UNITED STATES PATENT AND TRADEMARK OFFICE

APPLICATION NO.	FI	LING DATE	FIRST NAMED INVENTOR	ATTORNEY DOCKET NO.	CONFIRMATION NO.
10/624,820		07/21/2003	John H. Rallis	P3179	7373
30143	7590	03/11/2005		EXAMINER	
TODD N. F		•	ADAMS, GREGORY W		
119 N. COMMERCIAL ST. #620 BELLINGHAM, WA 98225				ART UNIT	PAPER NUMBER
				3652

DETAILED ACTION

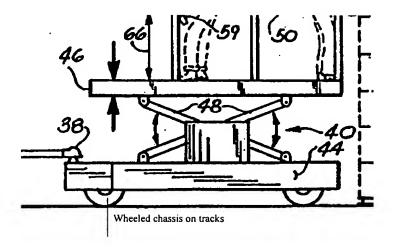
- 13. With respect to claim 4, referring to FIGS. 1-4 Doster et al. disclose a means for elevating a conveyor deck 37 comprising a scissor jack 48.
- 14. With respect to claim 5, referring to FIGS. 1-4 Doster et al. a means for selectively moving a traveling conveyor 37 comprising a wheeled chassis (as shown in Doster et al. FIG. 2 below), one track for wheeled chassis.
